Product Change Notice (PCN)

PCN Number: **PCN-0451089R-01**

Product(s) Affected: *PJ-041-SMT-TR*

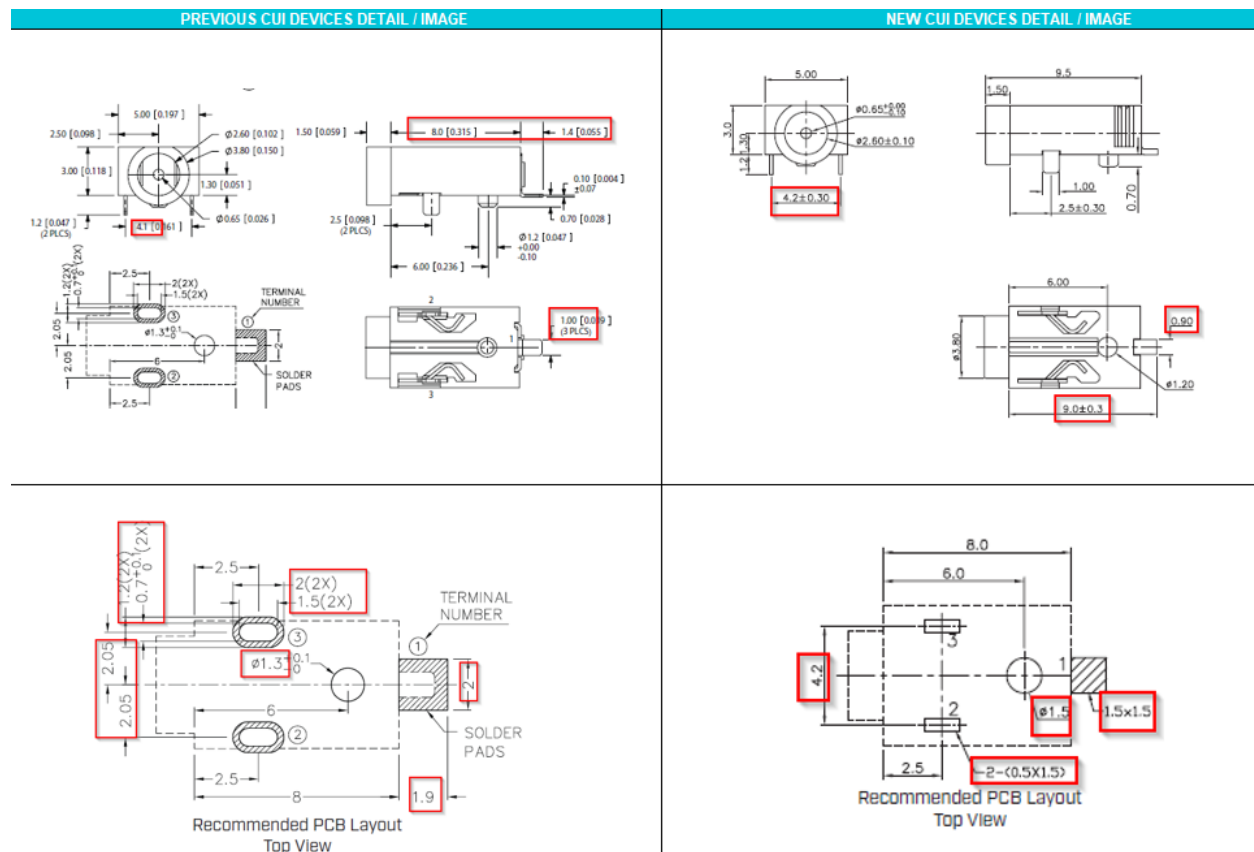
Description of Change: *Minor Housing and footprint differences. Material Change on the housing and terminals. PCB pad sizes, spacings differ. New part will fit on previous footprint. See image Below*

PREVIOUS CUI DEVICES DETAIL / IMAGE			NEW CUI DEVICES DETAIL / IMAGE		
	MATERIAL	PLATING		DESCRIPTION	PLATING/COLOR
center pin	copper	nickel		center pin	bronze silver
terminal 1	brass	silver		terminal 1	bronze silver
terminal 2	copper alloy	silver		terminal 2	SUS301 t=0.20 gold
terminal 3	copper alloy	silver		terminal 3	SUS301 t=0.20 gold
plastic	PBT or equivalent			housing	PA10T (UL94V-0) black
